# STAFF RECOMMENDATION

NCPC File No. 6903

## FORT BELVOIR BRAC 133 PROJECT, MARK CENTER DEVELOPMENT (WASHINGTON HEADQUARTERS SERVICES)

December 30, 2009

**BRAC 133 – WHS Complex  
PERIMETER SECURITY**

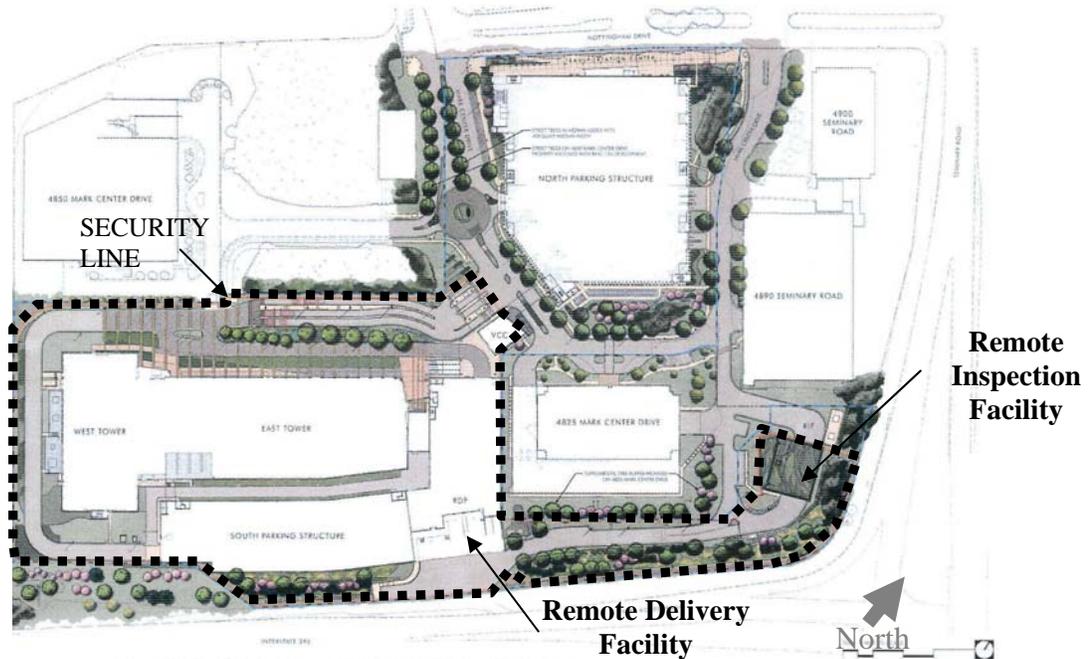
As the layout of the roadways has changed, so has the location of the security line of the campus. In an effort to address some of the City's concerns about isolating the CNAC building, the North Parking Garage in the North Campus has been altered by relocating the Visitor's Center into the South Campus and bridging Mark Center Drive with a covered, pedestrian walkway which allows the North Parking Garage to be outside the security perimeter. The change allows for the

security perimeter to encompass the South Campus and the RIF completely without encircling the CNAC Building.

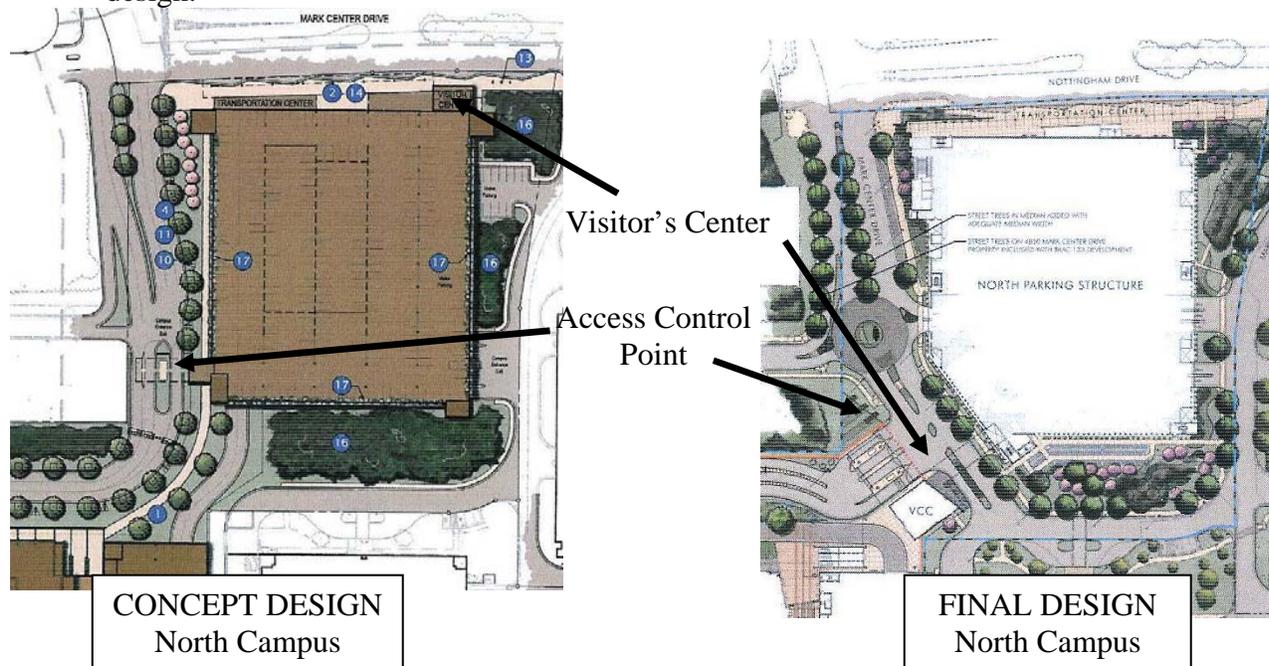
A second concern is with the architectural design. The City of Alexandria states the tops of the office towers and facades of the North Parking Garage need additional architectural refinement. Specifically, the City suggested a different architectural element at the top of the office towers than what is now proposed. The City prefers the rooftop architectural element to incorporate a smoother curve. In addition, the City of Alexandria has requested that the Army make design improvements to the North Parking Garage since it fronts along Nottingham Drive, one of the main entrances to the Mark Center. The changes requested include adding public art and more architecturally appealing façade expressions with the use of horizontal elements to enhance the pedestrian and vehicular experience. Staff **notes that the applicant has agreed to enhance the architectural expression of the North Parking Garage facade next to the Transportation Center by allowing wall space that can be used for public art.**

The City has also requested the following changes for the North Parking Garage:

- Use more glass for the stair and elevator towers on the western elevation of the North Parking Garage as these will be used by visitors and employees to gain access to the pedestrian bridge and into the office towers in the South Campus. The design of these elements will be the main experience for many visitors to this facility.
- Incorporate green roofs on the parking garage for environmental and aesthetic reasons.
- Articulation of the pedestrian walkway on the façade.

**CONCEPT SITE DESIGN  
FEBRUARY 2009**

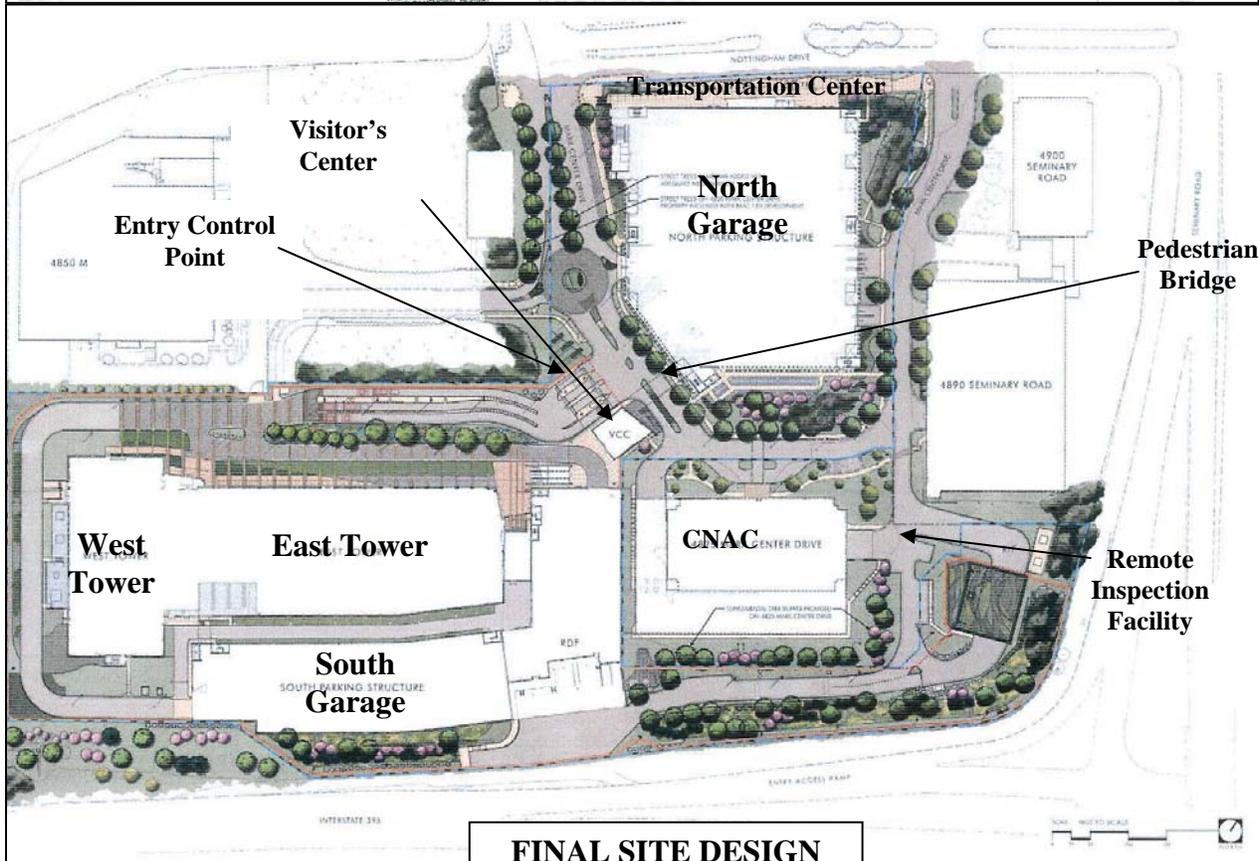
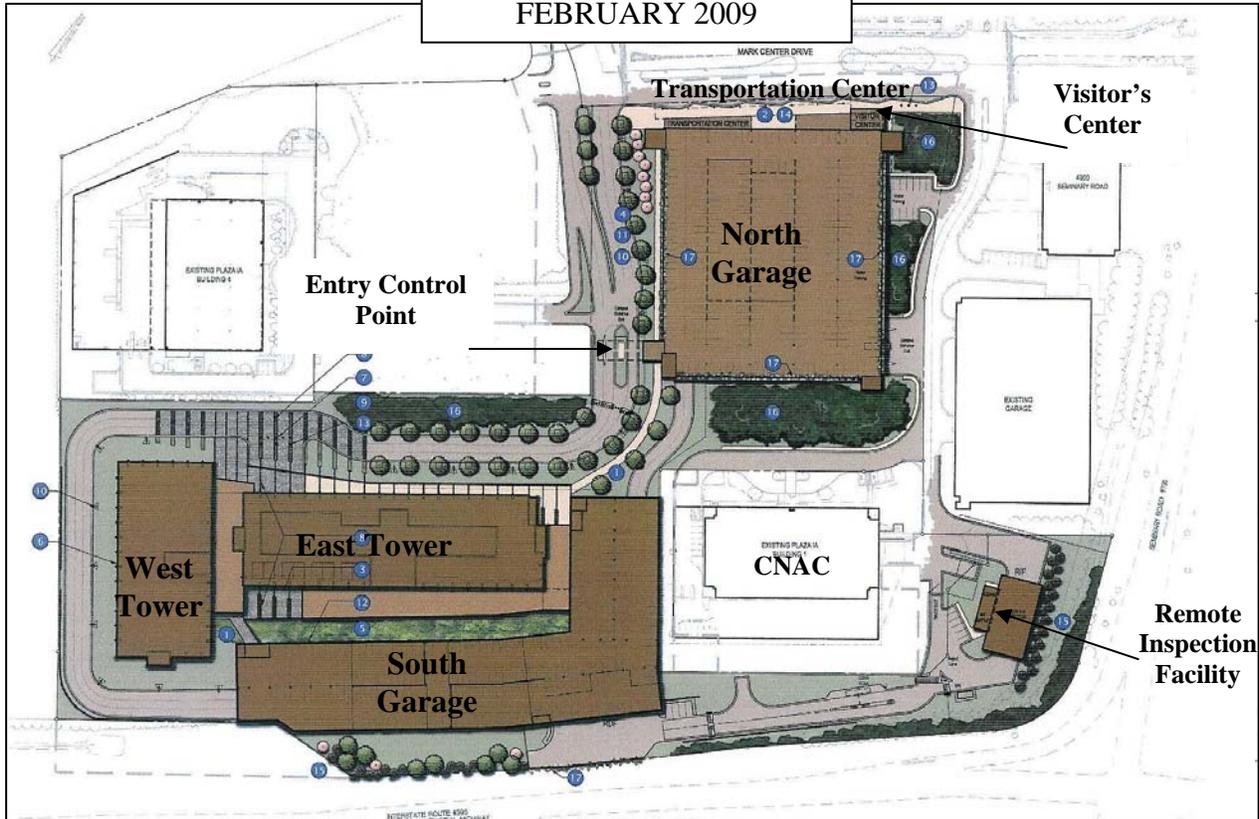
This project includes a redesign of the site layout and staff finds these changes are improvements that facilitate both vehicular and pedestrian movements within the site and allowing the CNAC Building to be less isolated on the campus. Most of these changes are the direct result of consultations with the City of Alexandria. The site layout changes include the following:

- Changing the location of the main access control point, North Parking Garage geometry and connecting road design to enhance vehicle and pedestrian circulation on the Mark Center campus internal street system.
- Revising the design of the remote inspection facility to include berming, step-terraced landscaping and green roof to help it blend in the with the landscaping
- Adjusting roads widths and sidewalks to create landscaped medians
- Integrating a landscaping bio-retention feature into the site’s access control roadway design.

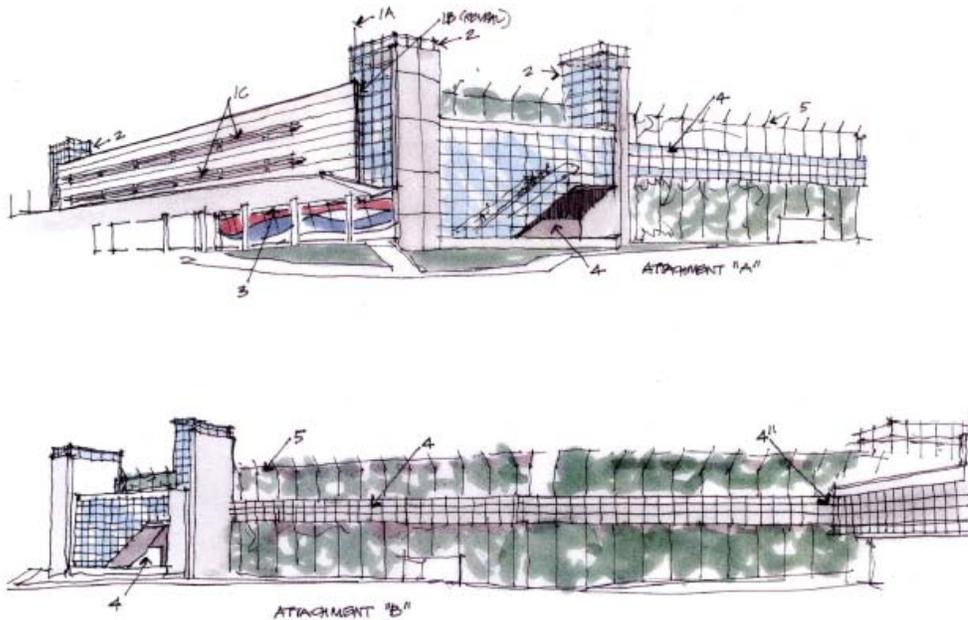
The five-level above-grade northern parking structure will be one of the most visible of all the buildings on the proposed BRAC campus and will be the building first experienced by most of the visitors. Unlike most of the parking within the City, which is located below-grade, this facility is a five-level above-grade structure with two levels of underground parking. While the City generally does not support above-grade parking structures, because of the limited City review authority over federally-owned projects such as this, the northern parking structure is proceeding as part of this DoD facility. The City is recommending that the north parking structure be designed to better integrate into the campus setting of the Mark Center, and also express the transportation function housed within the building.

As the roof of this structure will be visible from most of the surrounding office buildings and hotel, staff requested at Council's direction and at the request of the BRAC-133 Advisory Group that the parking structure incorporate a green roof on the uppermost deck level. After much discussion, it was determined by DoD in its view that it was not financially feasible to provide for the entire garage to have a green roof. For a \$1.1 billion construction project, a green roof would not represent an overall material cost addition to this project. However, it was discussed that some green elements be incorporated into the design of the top level of the garage. The City requests that NCPC indicate to DoD that the applicant should study this issue further looking at possibilities such as a trellis structure that could support some landscaping elements, or alternatively, the use of a lightweight shade structure, such as a fabric tensile solution, that could provide both shade for the parked cars, as well as an attractive feature for the buildings that will look down at this large roof area. Creating a green roof is consistent with the LEEDs Silver (minimum) or Gold (desired) plan of DoD.

To accomplish these objectives, the City has been working towards utilizing a landscaped green-screen for portions of the building facade internal to the campus. The front façade facing Mark Center Drive is a greater challenge because it is a five-level parking structure facing Mark Center Drive. While the parking structure does have a small transit facility on the ground level, most of the ground level will be inactive use (garage) adjacent to the bus stops. Duke Realty, the project developer, and the Army have worked with the City to improve the design of the facility and are continuing this effort. To address the remaining design concerns, the City is recommending the following:

- Incorporation of public art on the ground level referencing aspects of the history or prehistory of the site. This art work should be required to be installed prior to completion of the building.
- The use of color and metal accents to enhance the horizontal expression and reduce the perceived length of the Mark Center Drive façade.
- Integration of signage into the overall design.
- Refinement of the stair towers and other pedestrian circulation elements.
- Incorporation of green elements into the roof design such as a trellis structure, landscaping, or comparable elements.
